Control No. 975805A	To: FERMILAB	JTY / KTY Appr.
Last Revision 02	Part no. DO-CAL-PA-V2-D	Drawn By: 10/2/97

SCHEMATIC

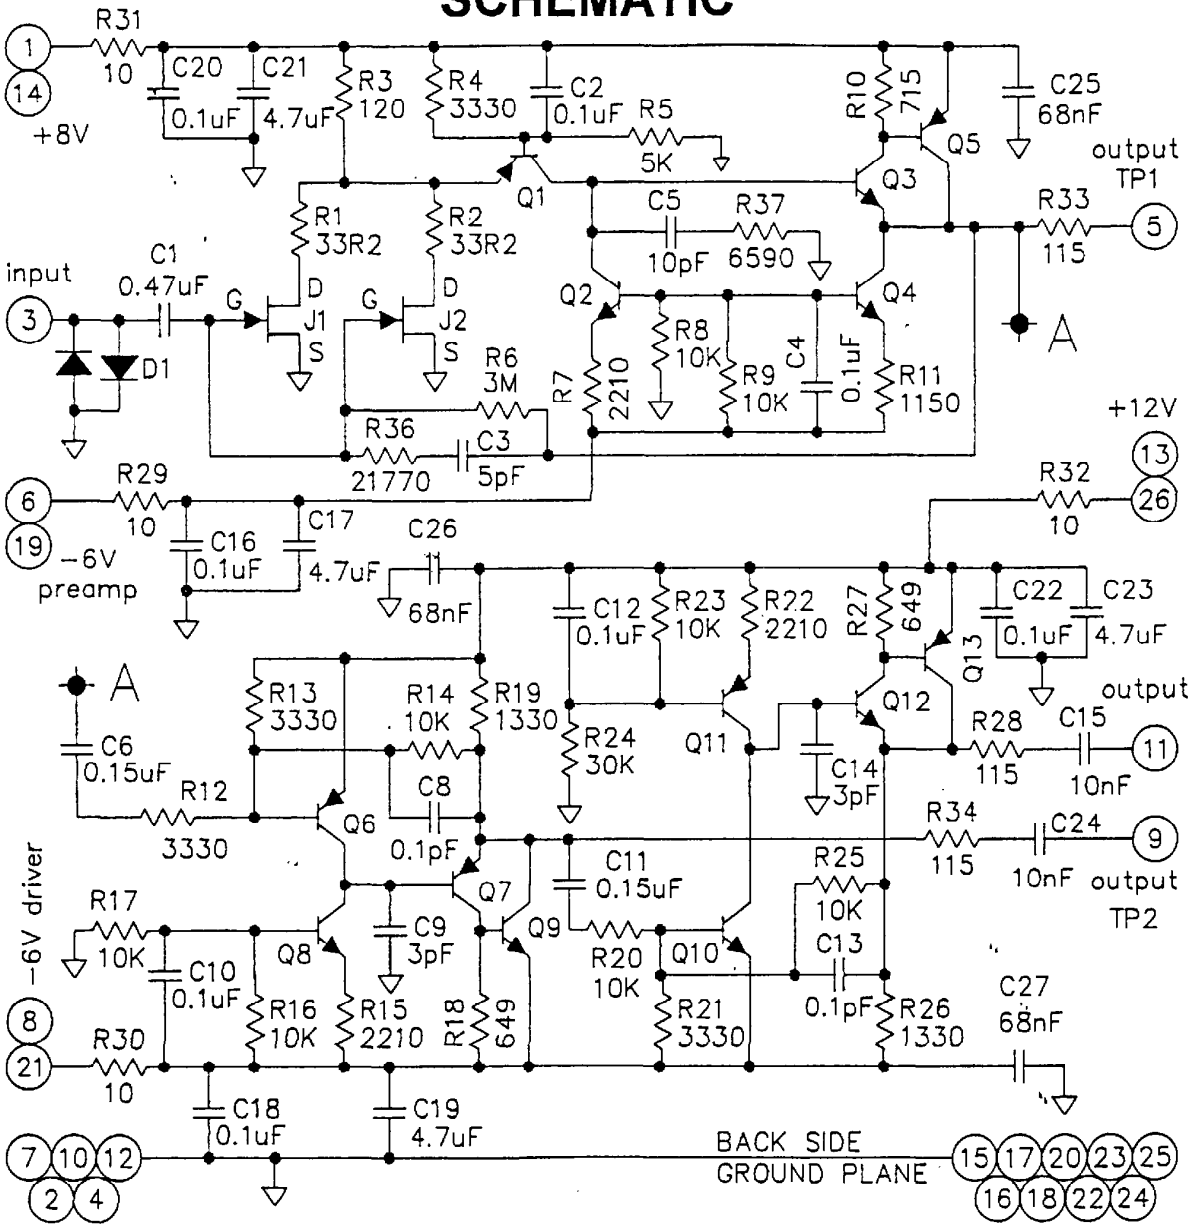
Rev.		By / Date
02	Change R3 from 178 to 120, R36 from 21768 to 21770, and R37 from 10884 to 6590.	RB 9/15/98
